Planning & Zoning Commission

REGULAR MEETING

Thursday, October 28, 2021 @ 6:00 P.M.

Re: Site Plan Comment Responses
Heritage Hills Multi-Family
NWQ US 67 & Heritage Hills Parkway
DEC No. 10551

CITY FILE NO.
-
SHEET NO.
C2.1

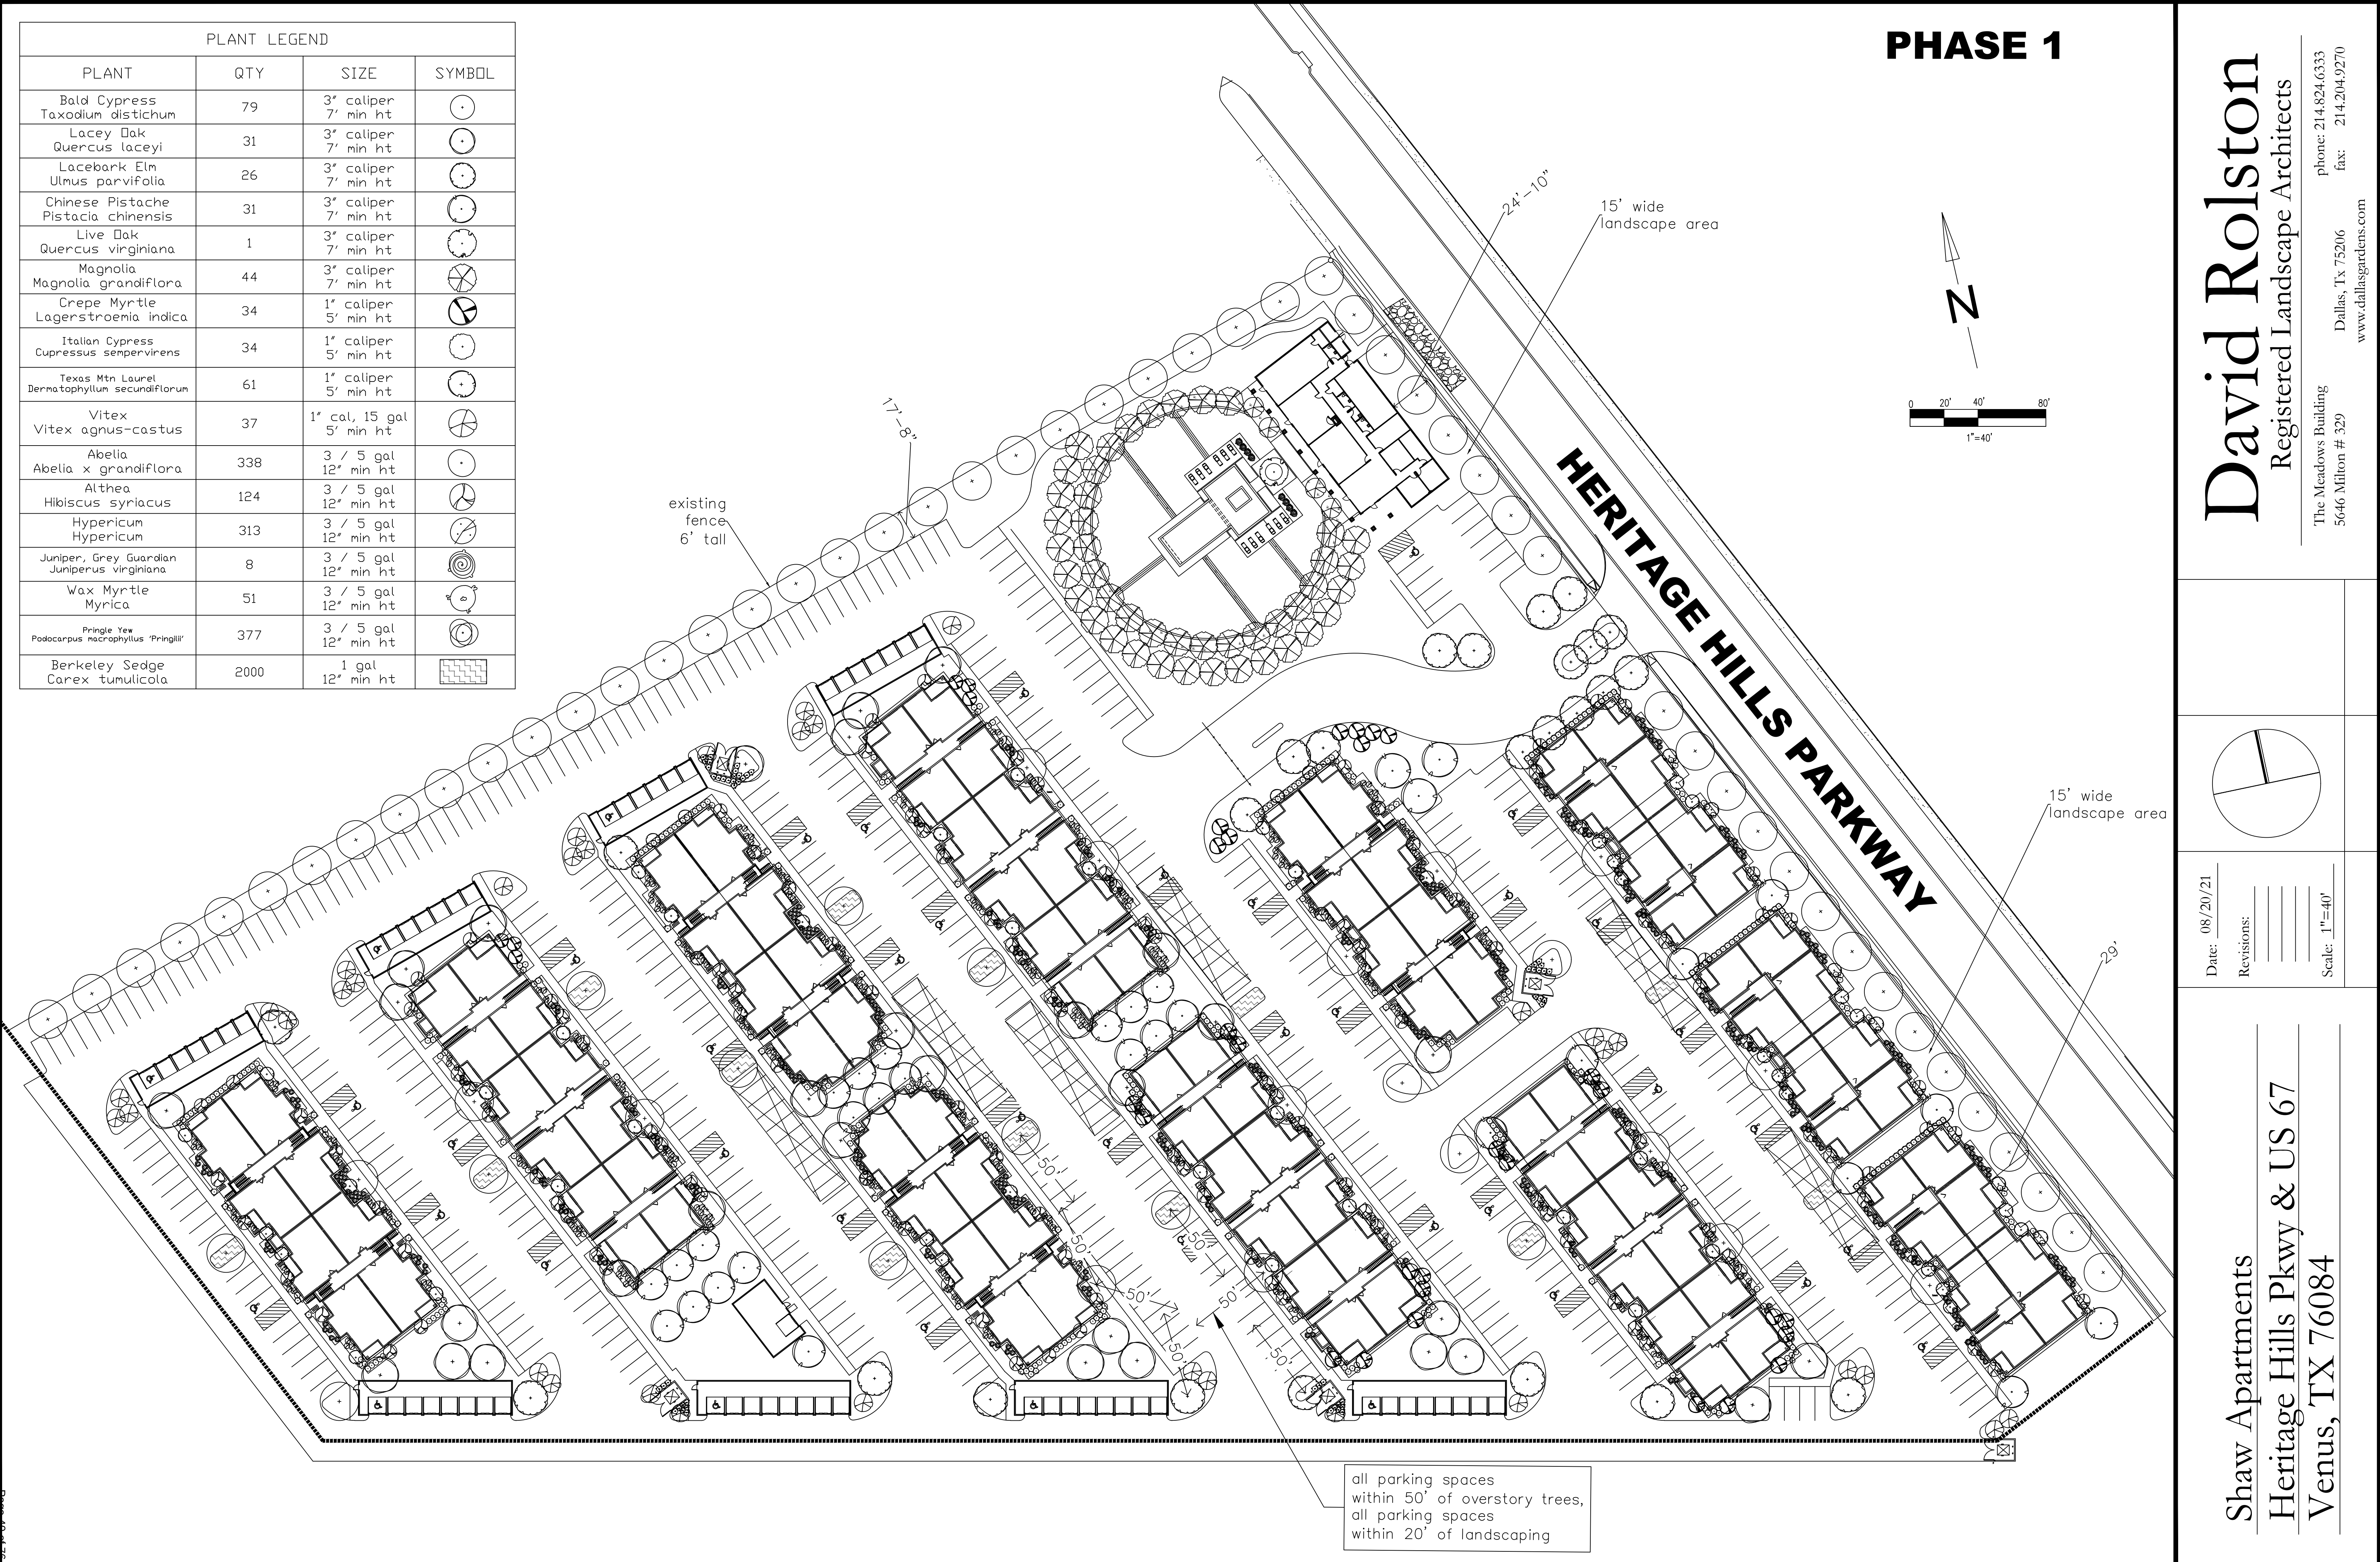
Comment	Response
SITE PLAN – SHEET C2.1	
1. The PD Site Plan is being evaluated against PD Ordinance No. 660-2018-06. Any criteria not addressed by the PD Ordinance are evaluated against the City of Venus Zoning Ordinance and Subdivision Ordinance.	Comment acknowledged.

2. Please clarify the acreage of Phase I, Phase II and the remainder the tract. Please clarify the differences between the “Provided – Phase I” and “Full Build out” columns in the Site Data table. I assume that Full Buildout includes both Phase I and Phase II.	Added a column showing data for Phase 2 and re-named “Full Buildout” column to Total, which includes both phases.

3. Please provide “elevation views or renderings indicating architectural design”, proposed building materials (PD Ordinance calls for 70 percent masonry) and window orientation, and locations of building entrances and exits.	Elevations are intended to meet PD requirements and will be provided upon completion.

4. Please provide dimensions and proposed construction of proposed drives and parking spaces. Please note that fire lanes with fire hydrants shall be 26-feet wide. Please show the curve radii for each turn of the fire lane.	Added labels and dimensions

5. Will entrances be open or gated?	Gated. Added labels.

6. We note a proposed 5-foot sidewalk along Heritage Hills Parkway. Please show it extending to the south drive approach. Please show how pedestrians may enter the facility.	Extended sidewalk.
---	--------------------

7. Please show the proposed fire hydrant locations on the site plan and/or the water and sanitary sewer layout.	Added hydrants to both plans.
---	-------------------------------

LANDSCAPE PLAN

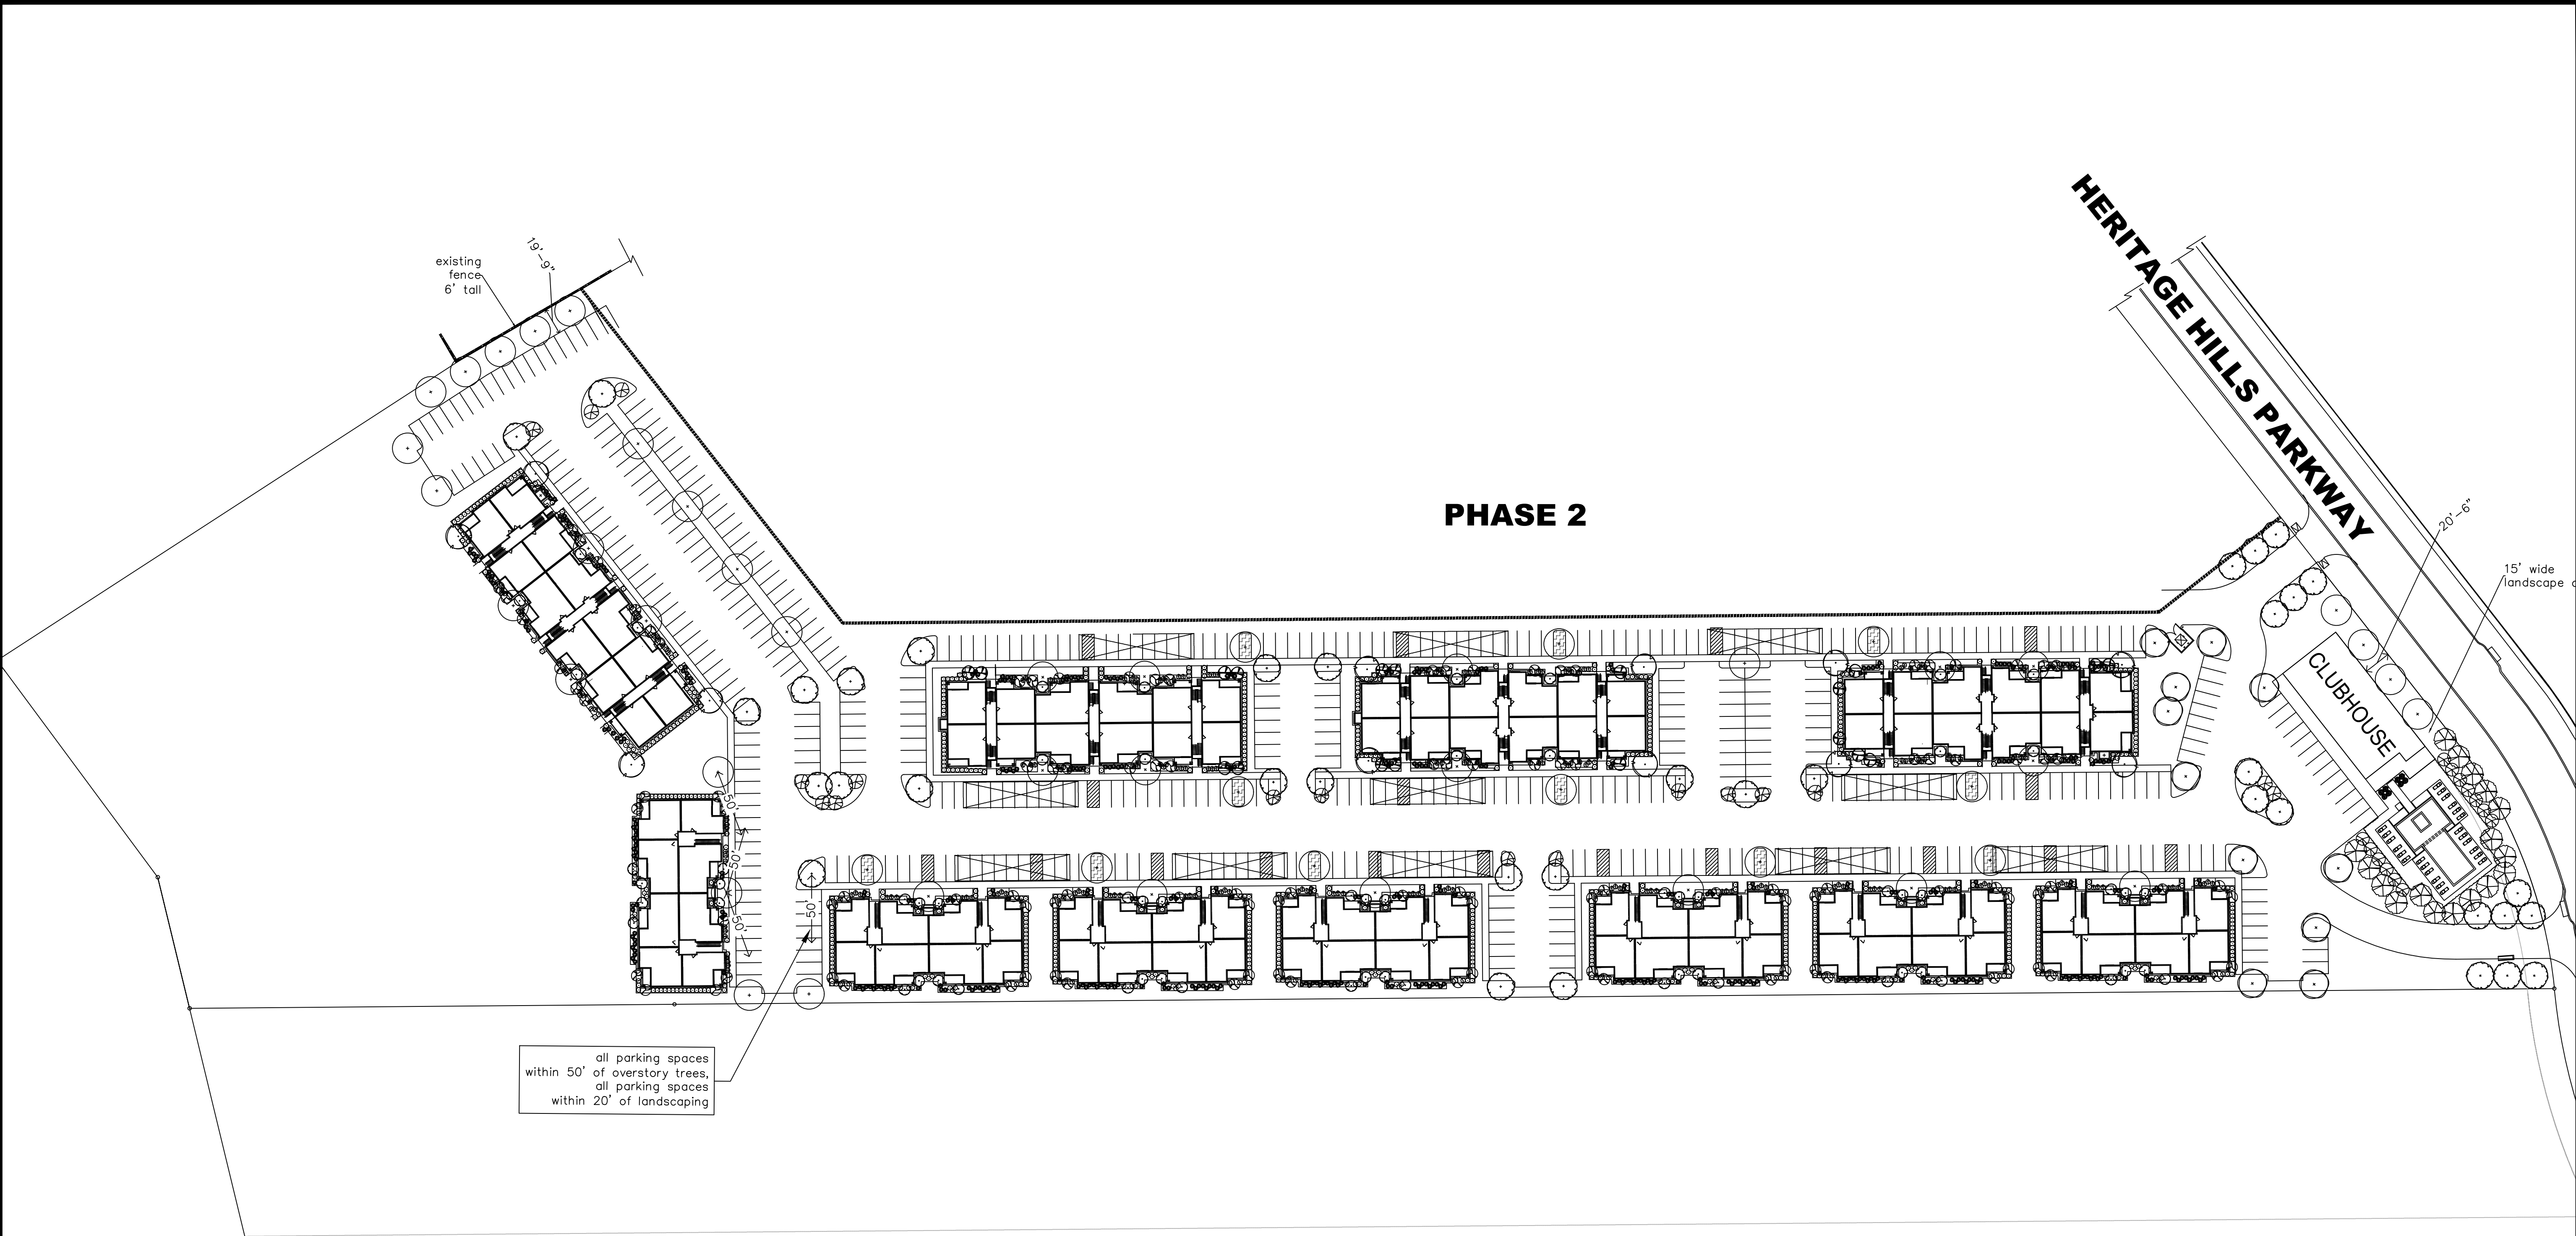
8. Please add a scale and north arrow.	Added scale and north arrow.
--	------------------------------

9. No screening is shown along the north property line between the multi-family and the four-plexes to the north. At a minimum, a six-foot fence shall be shown along with a 20-foot wide landscaped buffer. We note that the PD Ordinance does not require fencing along property lines. The PD Ordinance also calls for trees to be planed every 30 feet adjacent to property zoned single family (including four-plexes.)	Added trees along the north side and labeled the existing fencing. There is no minimum dimension for the landscape requirement in the PD other than what is adequate to support the required trees.
--	---

10. Most of the species call-outs are too small to read. Please provide a key to the plant types.	Added plant legend.
---	---------------------

11. Please show a 15-foot wide landscape area along the Heritage Hills Parkway frontage.	Labeled the landscape buffer along Heritage Hills.
--	--

12. Please demonstrate that every parking space is within 50 feet of an overstory tree and within 20 feet of a landscaped area.	Added note to confirm distance requirement as well as some representative dimensions. Dimensioning the entire plan decreased clarity.
---	---
